AUTOMATIC GEARBOX LEAKS.

LOOSENING OF TORUS COVER SETSCREWS AND  
CONSEQUENT OIL LEAKAGE FROM AUTOMATIC  
GEARBOXES.

AUTOMATIC GEARBOX.

### OIL SEALS - FRONT PUMP

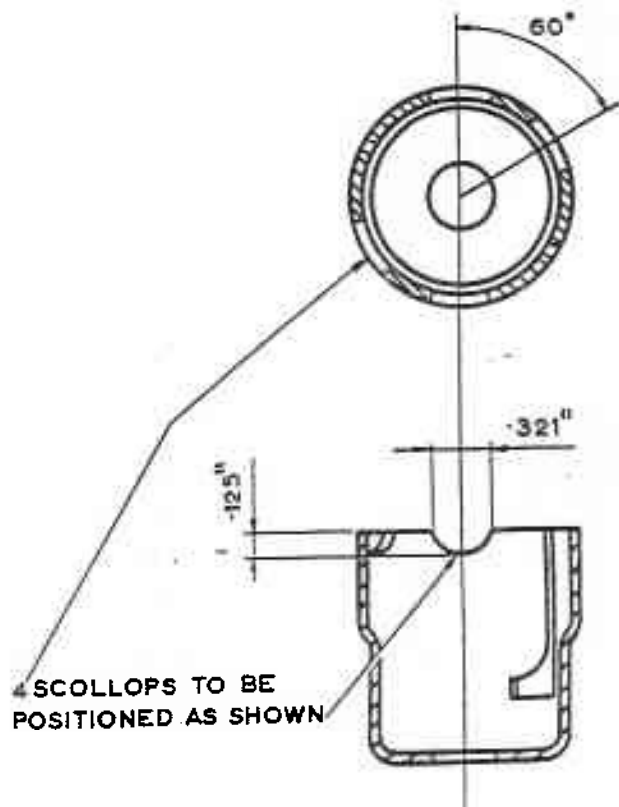
After prolonged running at high speed it may be possible for air pressure inside the gearbox to rise sufficiently to force oil through the normally satisfactory front pump oil seal.

This possibility is overcome by modifying the automatic gearbox oil breather and level indicator so that the pressure is relieved sufficiently to prevent oil leakage.

Take the oil breather and level indicator from the gearbox and carefully remove the retaining device securing the retaining cap to the indicator rod. The retaining device may be either a cee clip, spring clip, or split pin. This will allow the retaining cap, the copper mesh crimp and the serrated washer to be removed from the indicator rod. Cut the serrated washer and file the retaining cap as illustrated. Thoroughly clean and remove all metal particles, re-assemble the components and replace the assembly in the gearbox.

The time permitted for this work is one hour. The modified breather is evidence that these modifications have been incorporated.

Fig. 1.

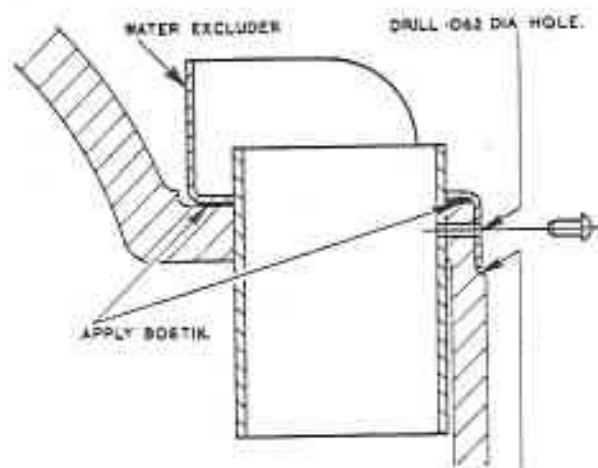
The following modification should be carried out to prevent water entering the gearbox by way of the dipstick aperture, only when the gearbox has already been removed for some other reason and is to be refitted into the chassis. All replacement gearboxes will incorporate this modification.

A small excluder in the form of a semi-circular shield is to be fitted around the dipstick guide, secured by a hammer drive hardened screw and sealed with Bostik to prevent ingress of water.

File a horizontal flat approx. 0.4" deep on the outside of the dipstick housing sufficiently deep to receive the right angled drilled location lip of the water excluder (see Fig. 1).

Locally clean surfaces free from dirt and oil, and remove the dipstick. Liberally coat the bottom of the water excluder and the matching surface of the dipstick housing with Bostik adhesive. Position the excluder over the dipstick sleeve and using the location lip as a guide, drill a 0.062" diam. hole through the dipstick housing and guide sleeve for the hardened hammer drive screw (see Fig.1). Ensure that no swarf enters the gearbox while drilling. Ascertain that the excluder is firmly stuck in place and hammer the hardened screw into position to securely retain the excluder.

FILE HORIZONTAL FLAT .400 DEEP  
TO RECEIVE EXCLUDER LIP.

Fig. 2.

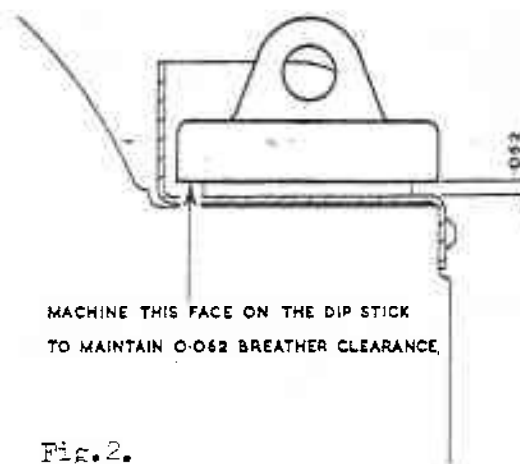
Machine the face of the dipstick as shown in figure 2 to allow 0.062" clearance for gearbox breathing. Clearly mark the top of the dipstick with RED paint to indicate that this has been carried out.

Fig.1. Pump Cover Checking Dimensions.

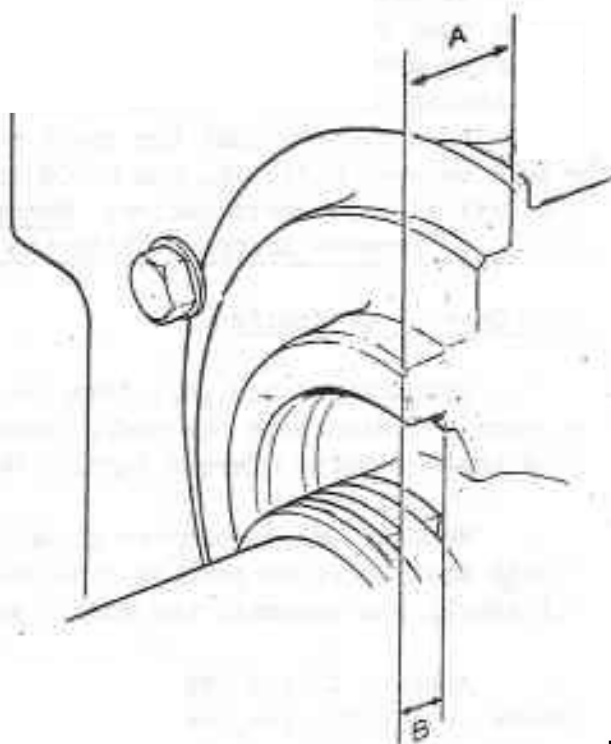
Difficulties have arisen concerning the fitting of the oil seal between the front pump cover and the torus cover. The following is a brief outline of the stages of modification in order of their introduction :

1. The seal fitted to S1 cars was pressed fully home into the annular locating recess. Early S2 cars had an identical seal (UG.3670), but this was not pressed fully into the recess. A modification was then introduced, interposing a washer between the seal and the recess end face in order to more effectively control the seal position.
2. A further modification incorporated the re-positioning of the seal recess on production pump covers so as to obviate the necessity for a packing washer.
3. Current S2 cars are being fitted with a new type of seal (UG.4107) requiring a recess position similar to that of stage 1 pumps. No packing washer is required and the seal is pressed fully into the recess so as to contact the end face.

Using a depth gauge or vernier callipers, measure dimensions 'A' and 'B' given in Figure 1. Subtract dimension 'B' from dimension 'A'. A result which lies between 0.355 in. and 0.400 in. indicates that the cover is not of the modified type and that a washer must be fitted; a result between 0.415 in. and 0.450 in. indicates a modified pump, requiring no action.

Insert the washer UG.3941 into the recess with chamfered face leading, apply a little 'Wellseal' jointing compound to the outer wall of the recess, lubricate the new seal with transmission fluid and tap the seal into position with a hide mallet.

Machine the pump cover to increase the depth (Dimension B., Fig.1) of the seal location bore by .050 in. Thoroughly clean the cover to remove all swarf, and assemble the pump. Refit the unit to the gearbox.
